**RESIDENTIAL PLAN CHECK  
 COMMENTS**

**PLAN CHECK NO:** 10172158

**PROJECT ADDRESS:** 717 E Third St

**PLAN CHECK ENGINEER:** Ahangian, Kathy **TEL: 714** 647-5812  
**FAX: 714** 647-5897

**Sheet Number**  
**A1.4**

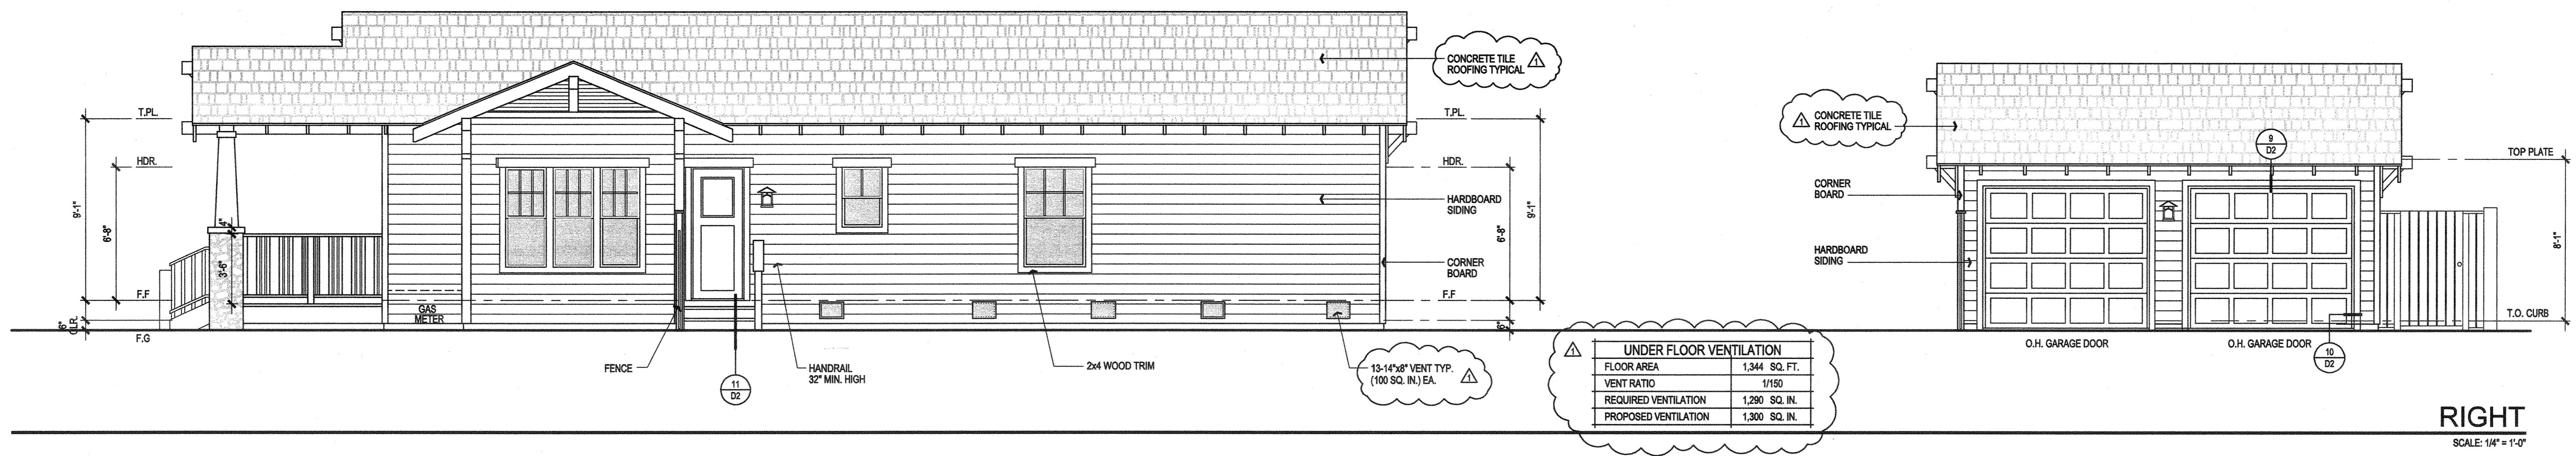
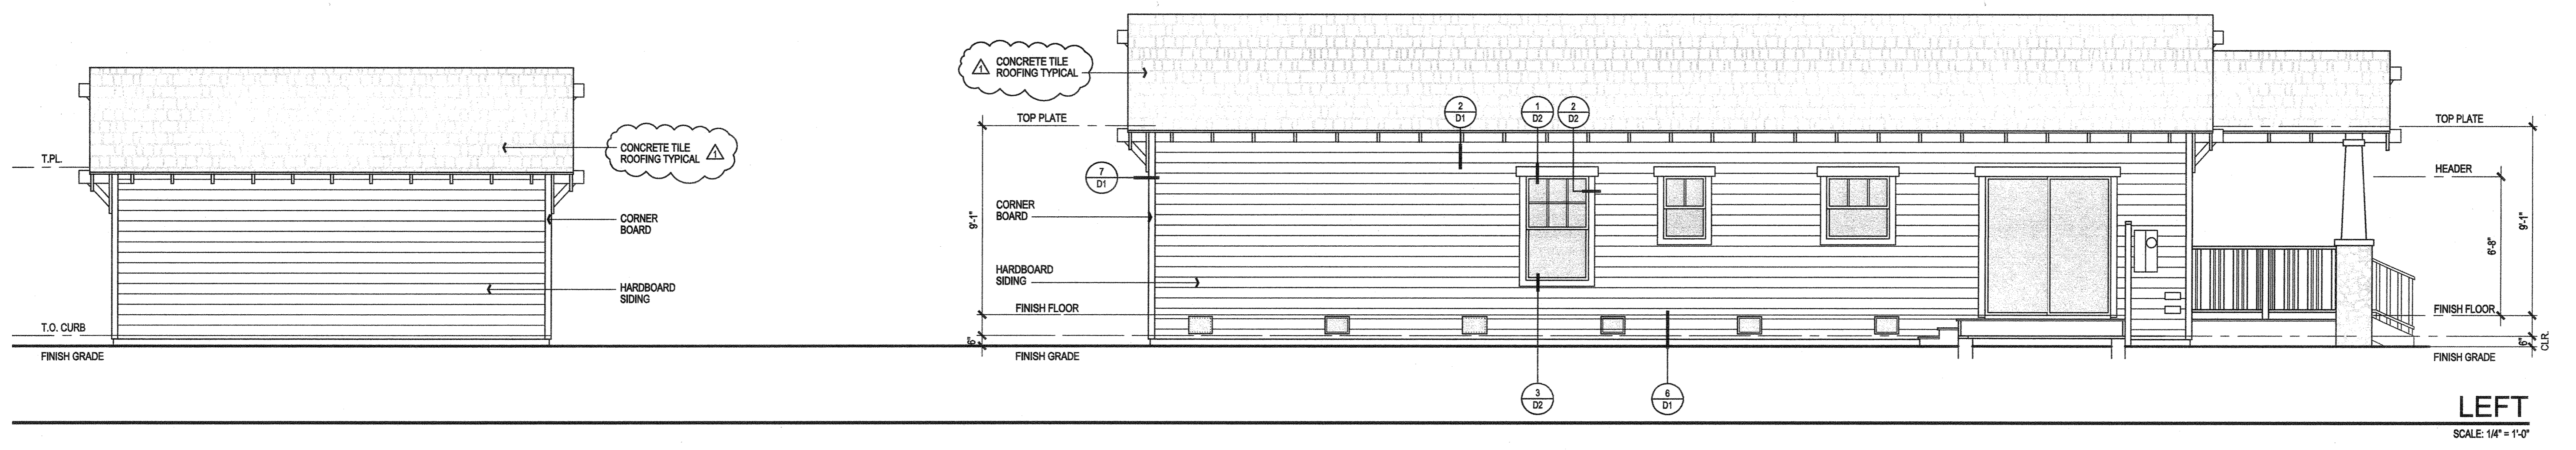
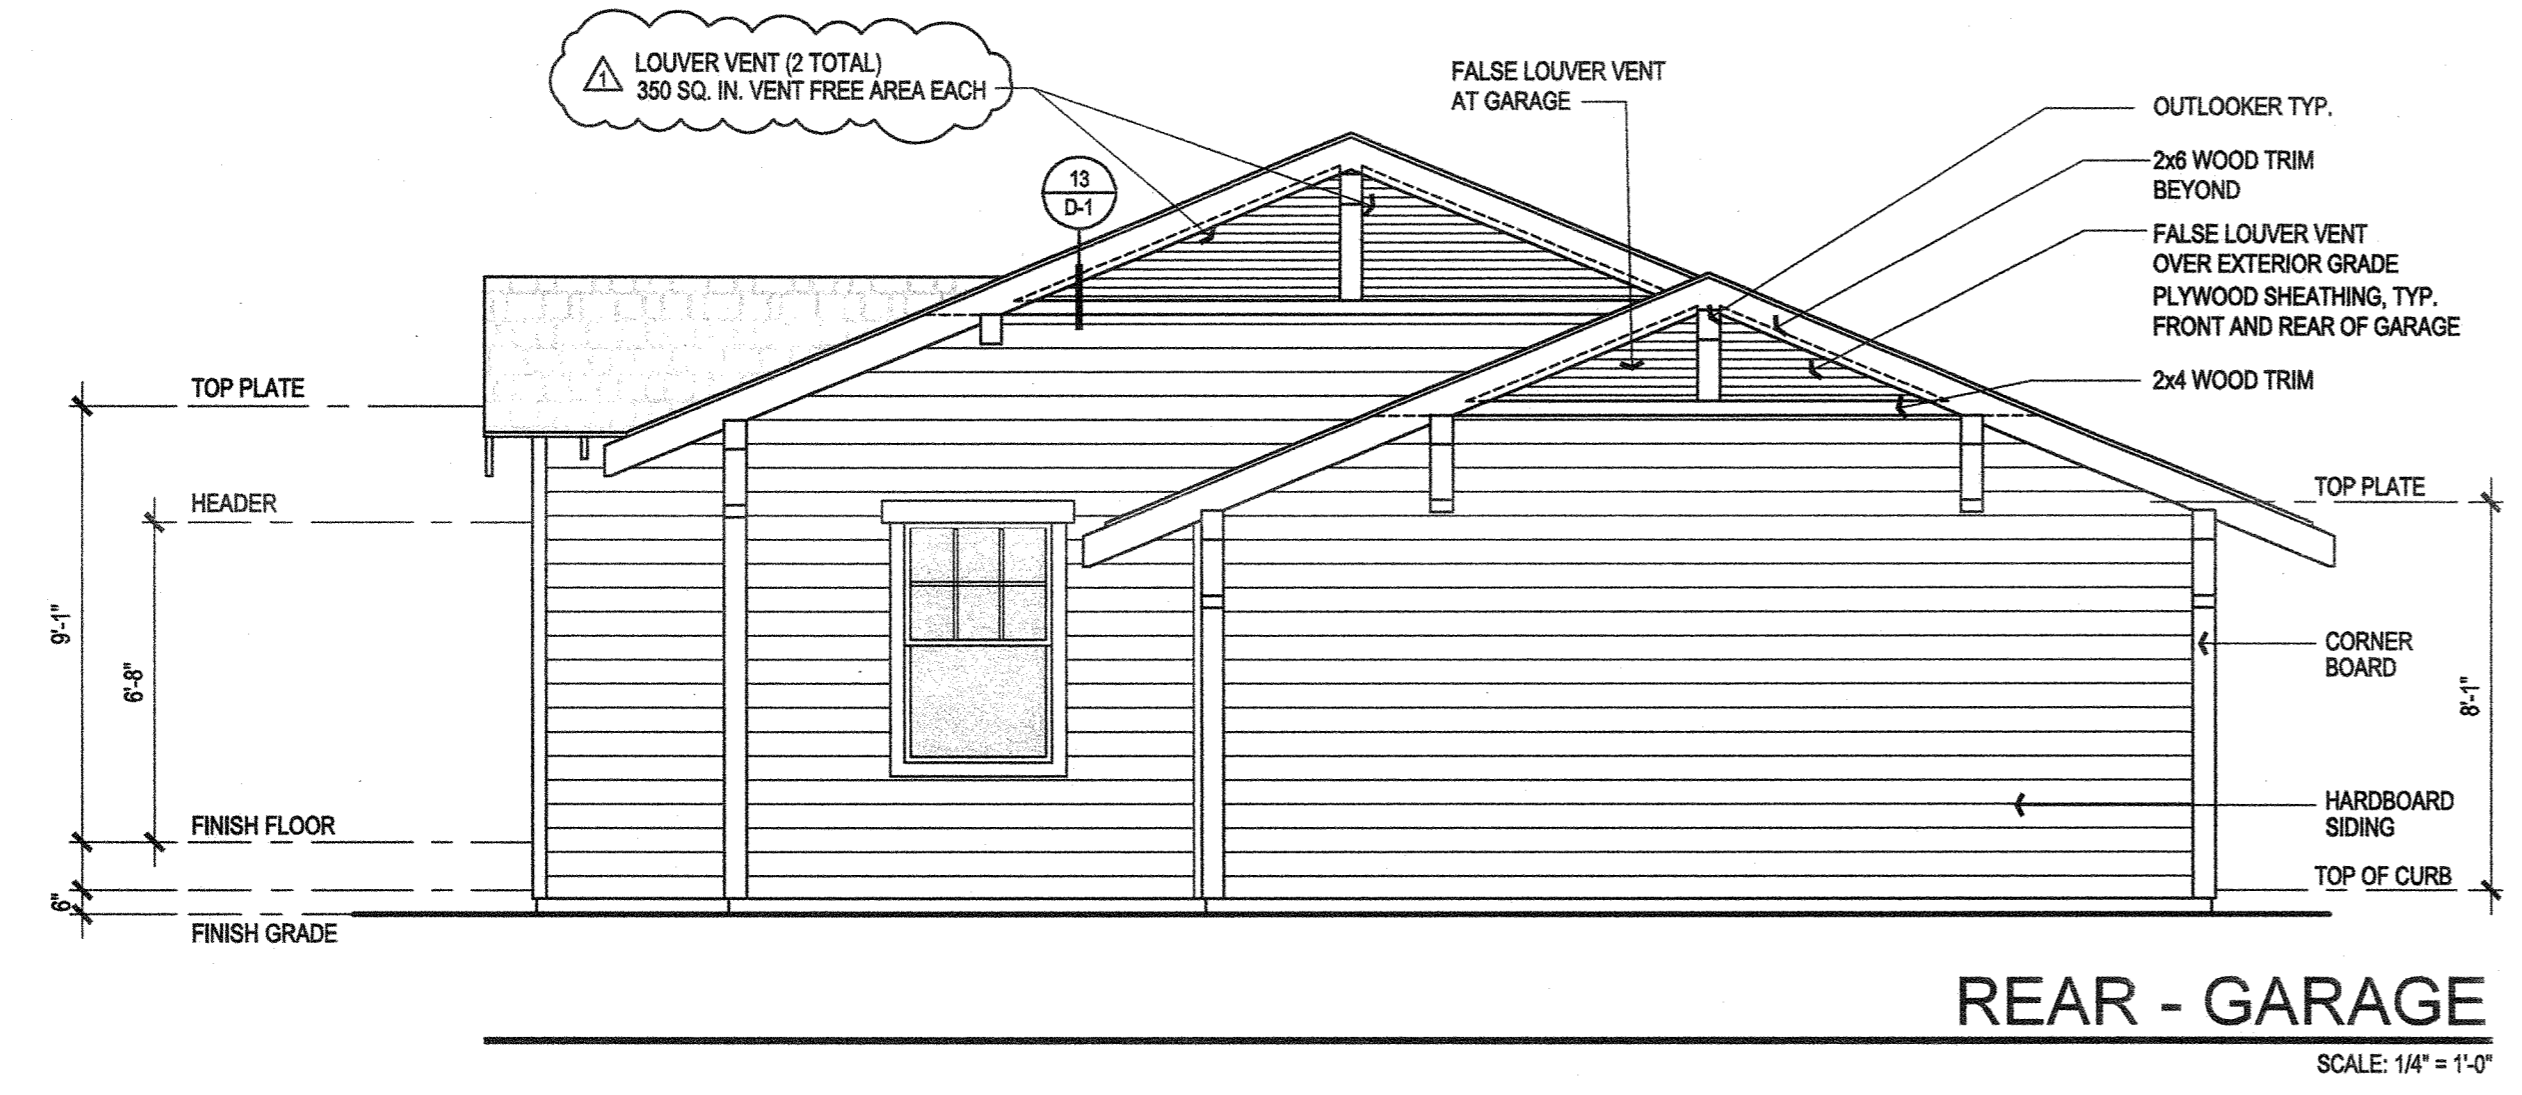
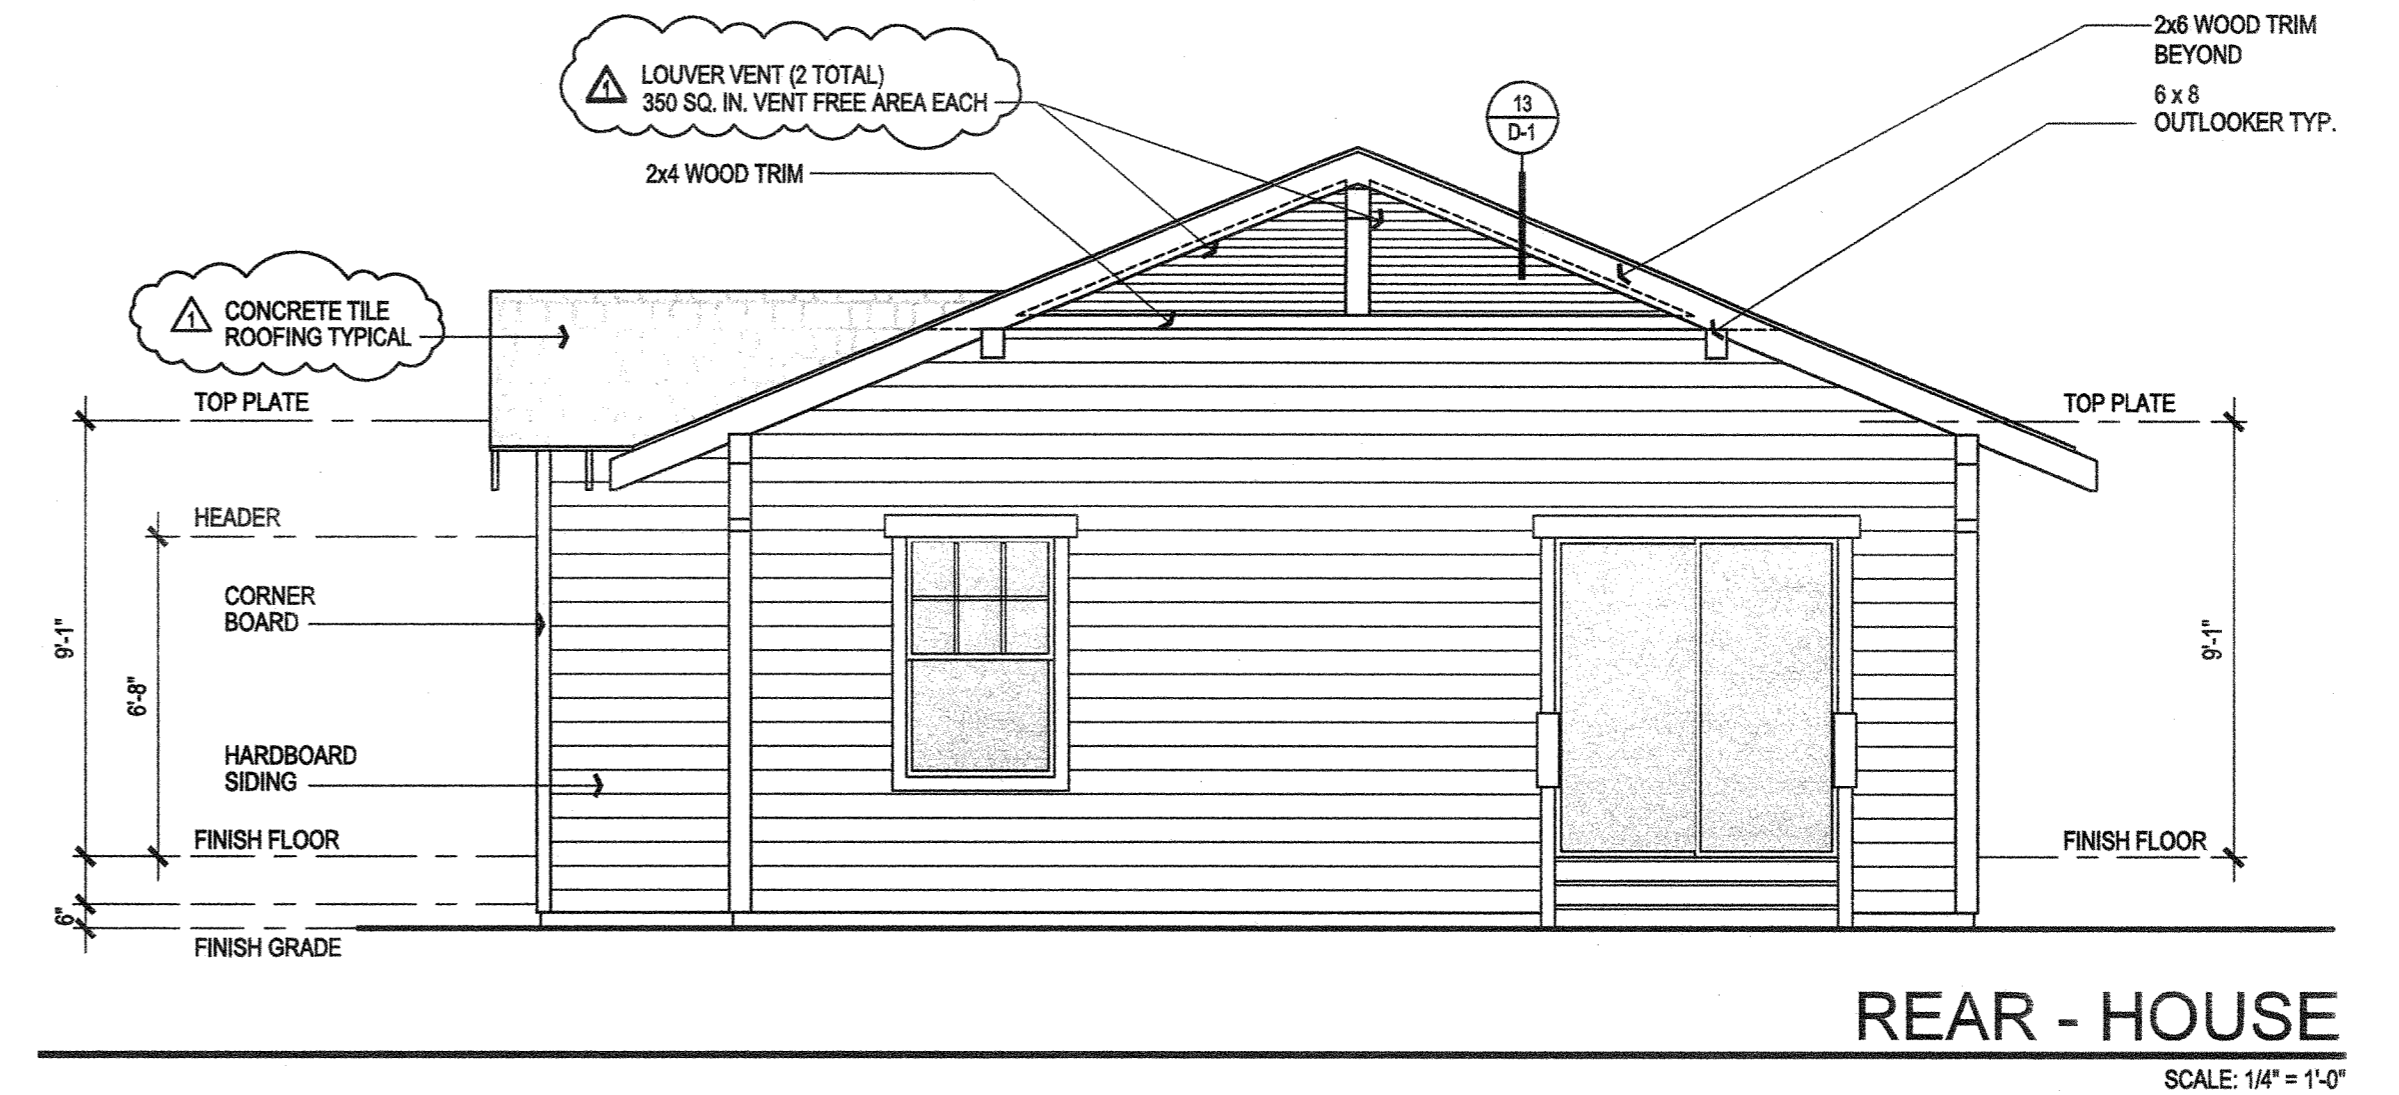
*10-21-11*  
15. Provide and show on the plans, house street number visible and legible from street. (Minimum 4"High x 1" Wide) CRC R319
